Re: MAS Charrter School/ West Parent Loop and Parking
99999 Yale Blvd. SE
Traffic Circulation Layout
Engineer's Stamp 04-17-23 (L16-D044)

Based upon the information provided in your submittal received 04-28-23, the above referenced plan cannot be approved for Building Permit until the following comments are addressed:

MAS CHARTER SCHOOL
WEST PARENT LOOP AND PARKING

SHEET TITLE
OVERALL
TRAFFIC
CIRCULATION
LAYOUT

SHEET NUMBER
TCL-01

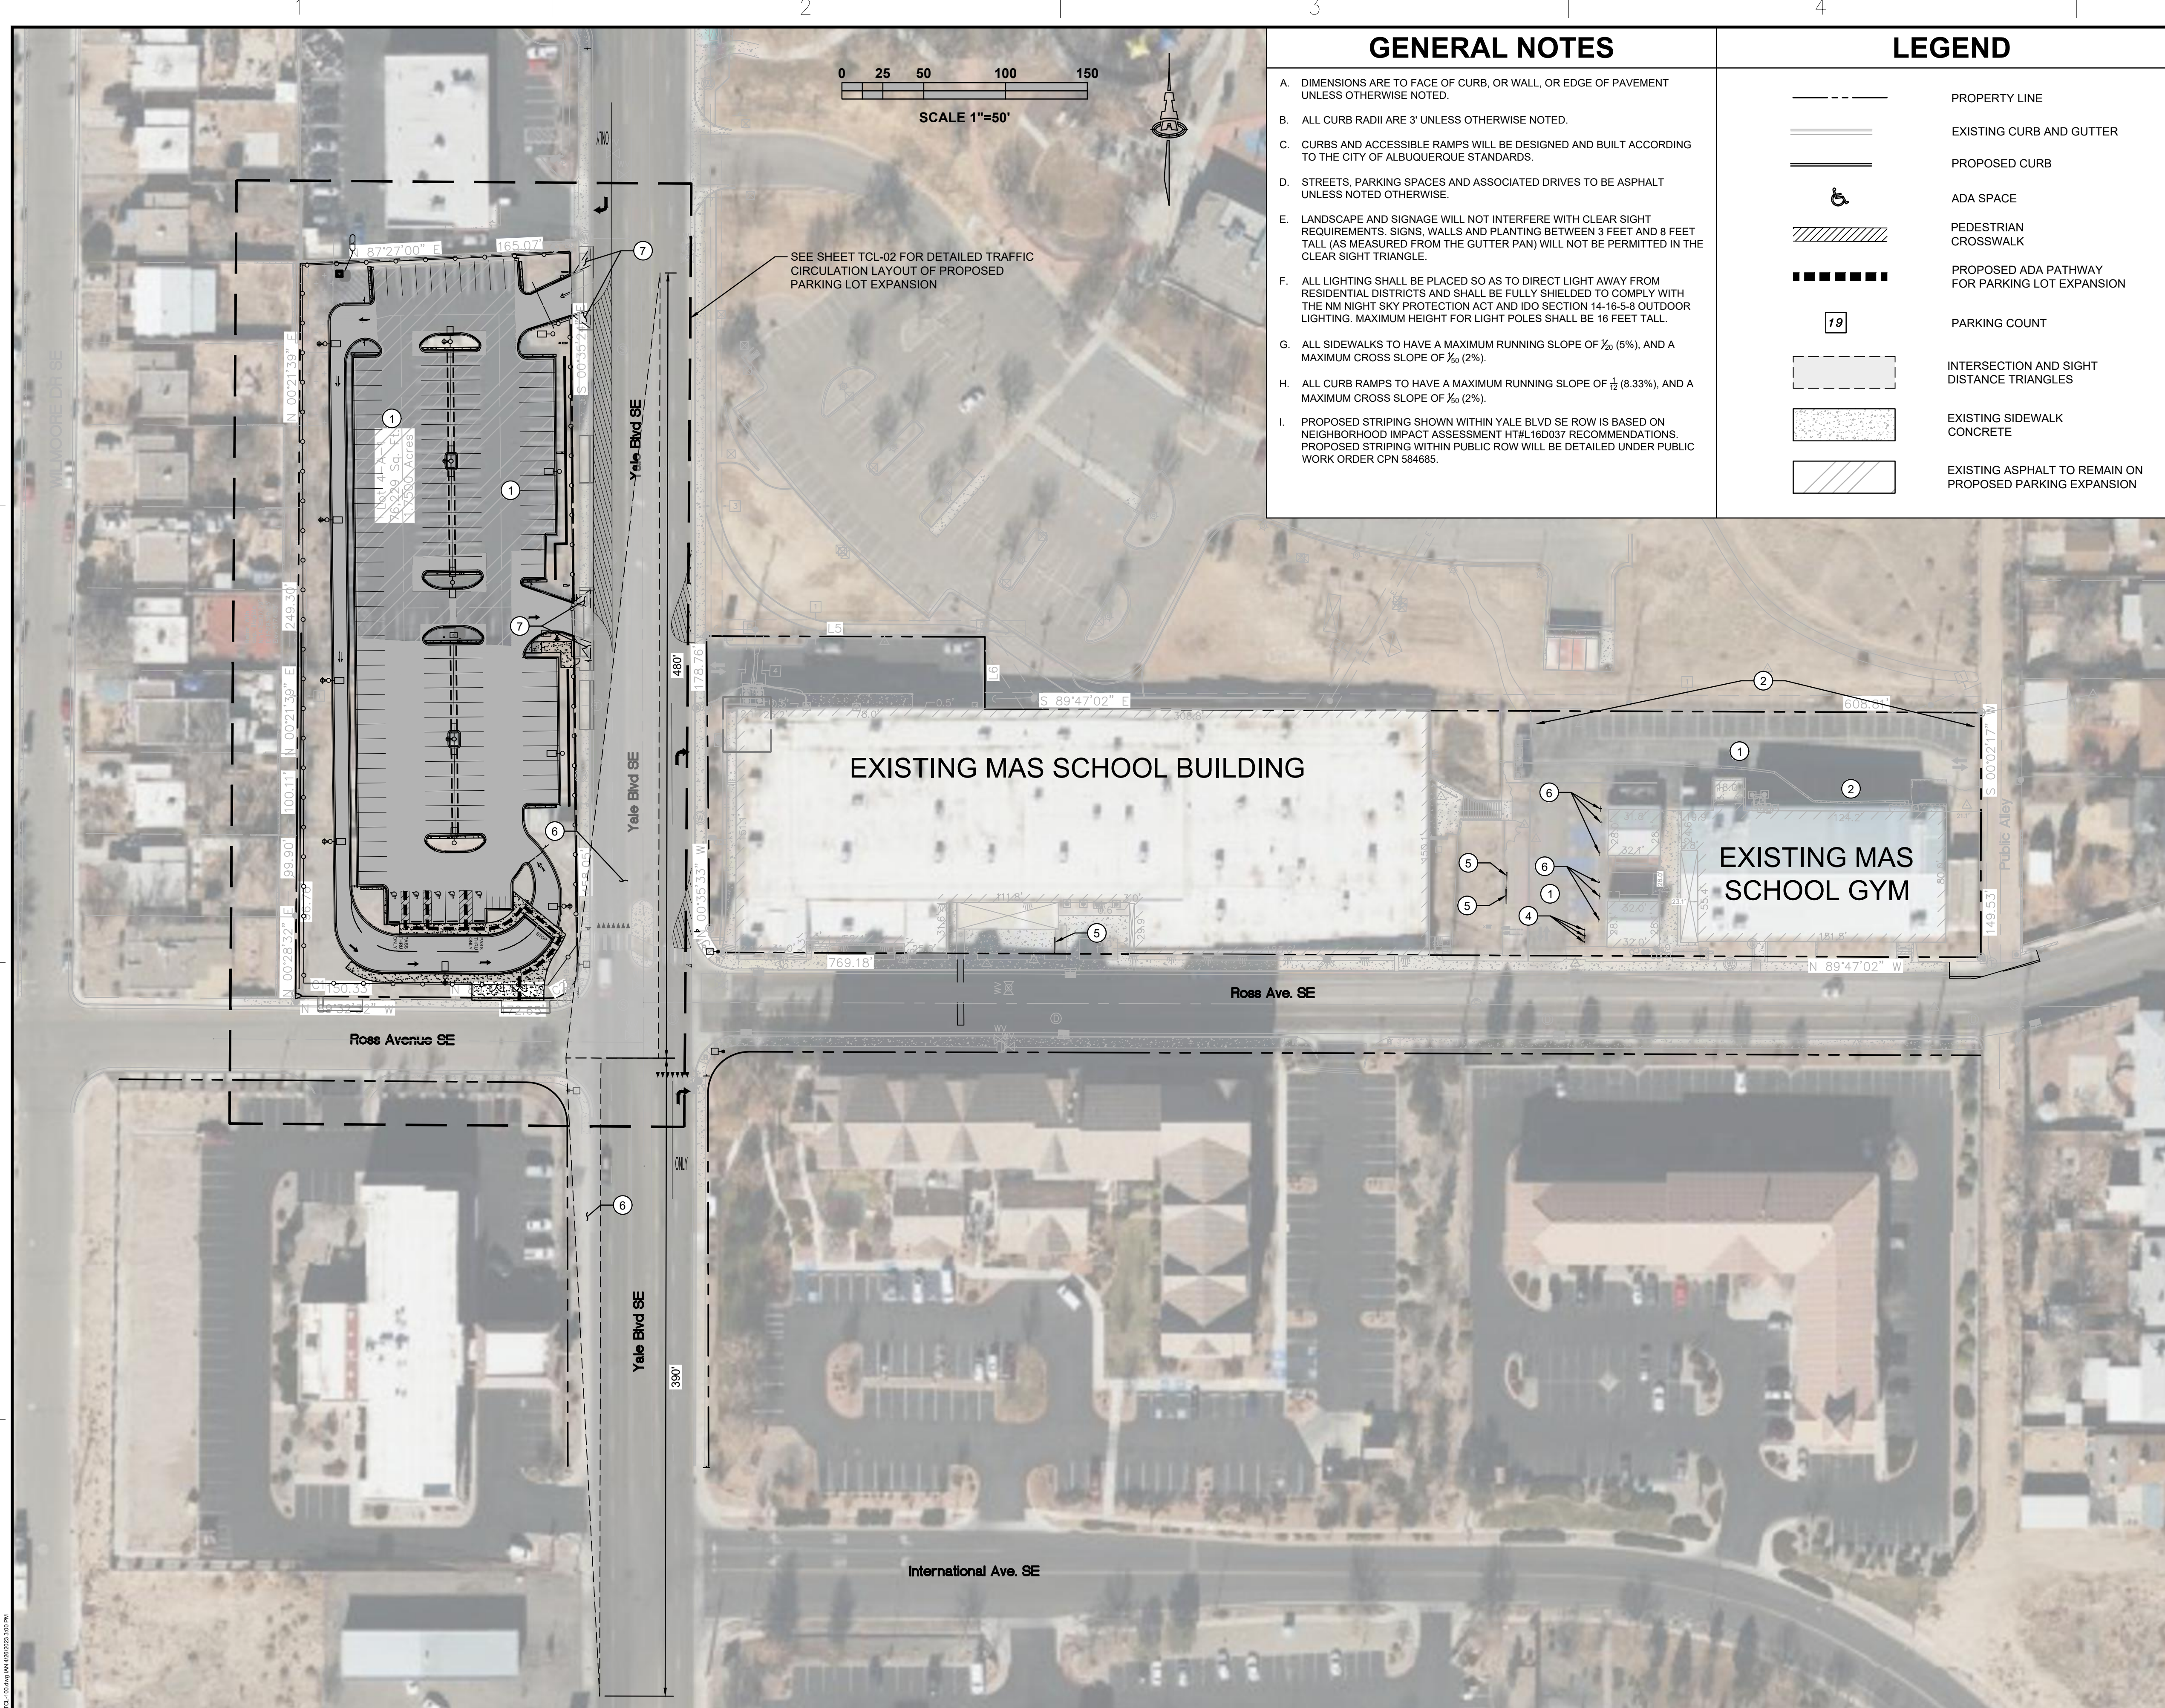
1. The traffic circulation layout must be signed by an engineer or architect licensed in the state of New Mexico.
2. Identify all existing access easements and rights of way width dimensions.

3. Driveway Accesses off Yale Blvd.:
 - Minimum accesses width should be 22 ft.
 - Both accesses must be updated to the current ADA standard.
 - Show on the site plan the required turned around before the gate (min. 20 ft. set back).

4. ADA curb ramp at the corner of Yale Blvd. and Ross Ave. must be updated to current standards and have truncated domes installed.
5. The pavement marking "MC" should be shown in the opposite direction for motorcycles entering the parking space.

6. Per DPM, a 6 ft. wide ADA accessible pedestrian pathway is required from the ADA parking stall access aisles to the building entrances. Please clearly show this pathway and provide details.

7. All one-way drives shall have "One Way" and "Do Not Enter" signage and pavement markings. Please show detail and location of posted signs and striping.

8. The minimum drive through lane width is 12 feet with a 25-foot minimum radius (inside edge) for all turns. (A 15-foot radius can be used with an increase in lane width to 14 feet). Please dimension all lane widths and radii.

9. Clear sight triangle should start at the back of the sidewalk. Please revise the site plan.
10. Please specify the City Standard Drawing Number when applicable.

11. Provide notes showing what work is included and on the work order and the private work on site.

12. Please add a note on the plan stating "All improvements located in the Right of Way must be included on the work order."
13. Unused curb cuts must be replaced with sidewalk and curb & gutter. A build note must be provided referring to the appropriate City Standard drawing.

14. Add a note stating "All broken or cracked sidewalk must be replaced with sidewalk and curb & gutter." A build note must be provided referring to the appropriate City Standard drawing.
